DATE REVISED	DATE REVISED	FED.RD. DIST.NO.	STATE	JOB NO.	SHEET NO.	TOTAL SHEETS
10/19/2026		6	ARK.	110812	2	107
		INDEX OF SHEETS AND STANDARD DRAWINGS

SCHEDULE OF BRIDGE QUANTITIES
HWY. 49 MISSISSIPPI RIVER BRIDGE REHAB. (S)
PHILLIPS COUNTY
ROUTE 49 SECTION 11
ARKANSAS STATE HIGHWAY COMMISSION
LITTLE ROCK, ARK.

SUMMARY OF ILLUMINATION & ITS QUANTITIES
HWY. 49 OVER MISSISSIPPI RIVER
HWY. 49 MISSISSIPPI RIVER BRIDGE REHAB. (S)
PHILLIPS COUNTY
ROUTE 49 SECTION 11
ARKANSAS STATE HIGHWAY COMMISSION
LITTLE ROCK, ARK.
DRAWN BY: JR DATE: 11/2025 FILENAME: B110812_E1.DGN
CHECKED BY: DM DATE: 11/2025 SCALE: NOT TO SCALE
DESIGNED BY: DB DATE: 11/2025
BRIDGE NO. 02899 DRAWING NO.

DETAILS OF FLOOR BEAM REPAIRS:
REPAIR TYPE D - STIFFENER REPLACEMENT
ROUTE SECTION
ARKANSAS STATE HIGHWAY COMMISSION
LITTLE ROCK, ARK.
DRAWN BY: LAC DATE: 07/2025 FILENAME: B110812_FB4.DGN
CHECKED BY: HSS DATE: 07/2025 SCALE: AS SHOWN
DESIGNED BY: MHA DATE: 07/2025
BRIDGE NO. 02899 DRAWING NO. 69569

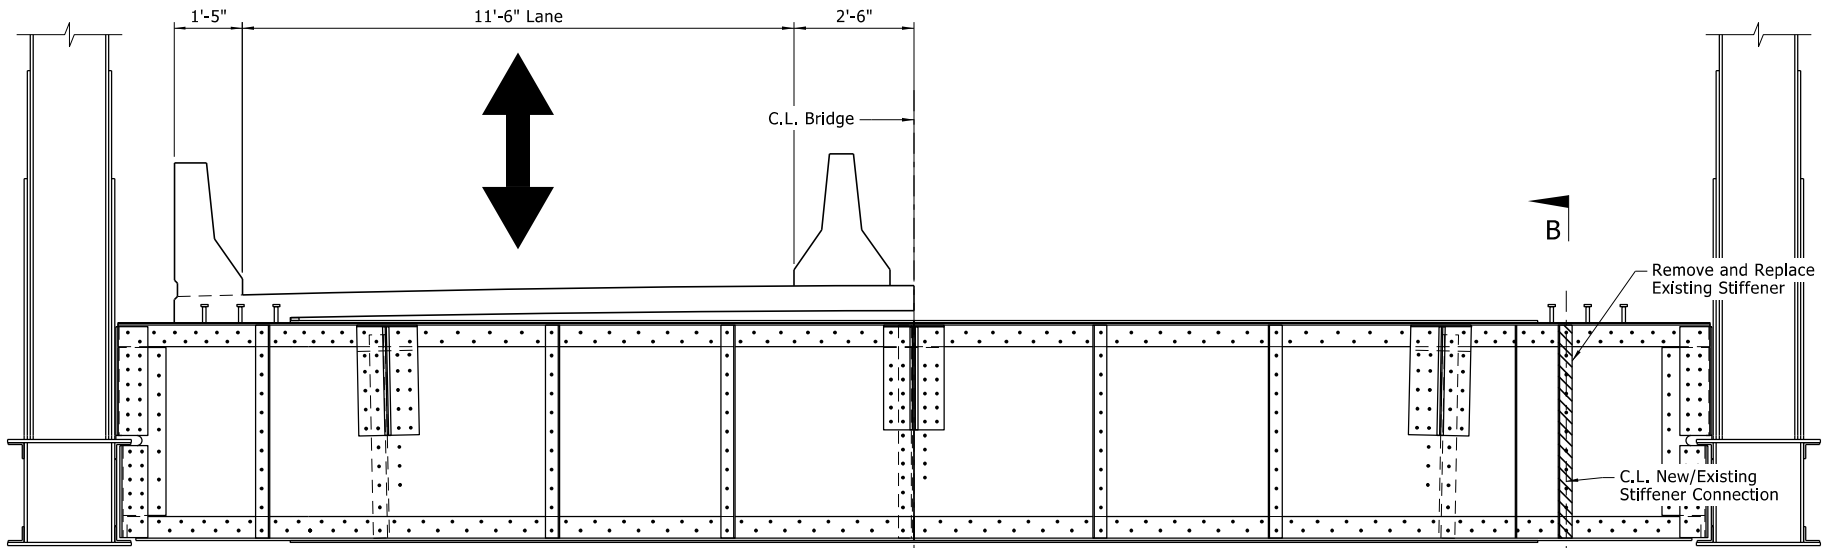
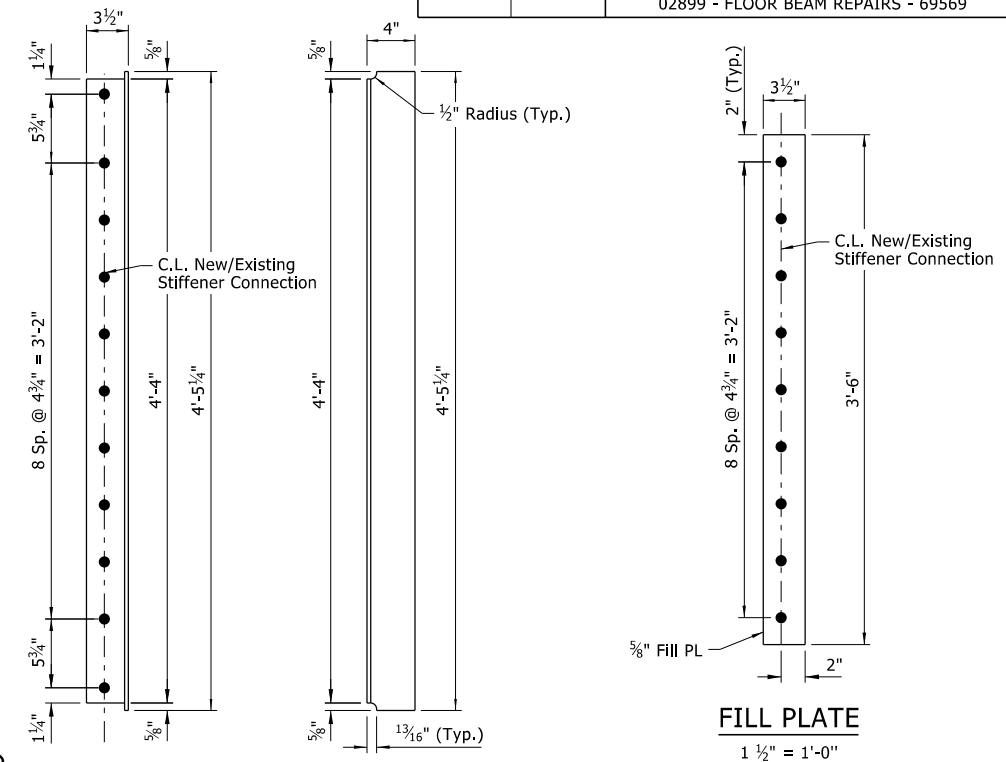
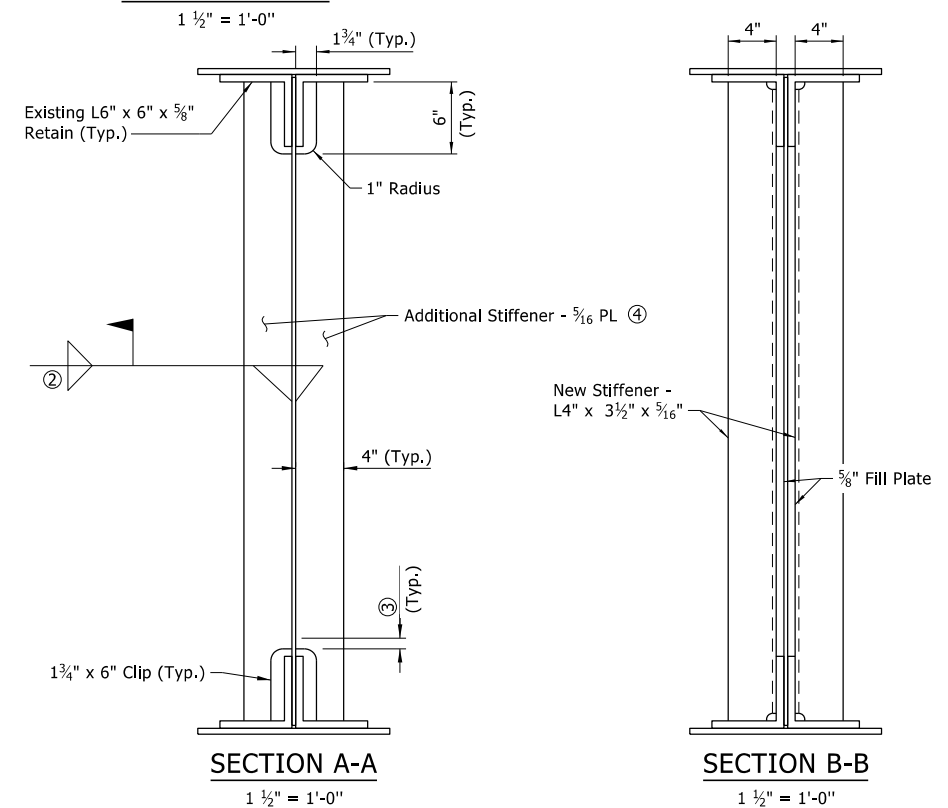
Revised to add clip for fit.
By: MKL 10/19/2026
Checked by: HSS 10/19/2026
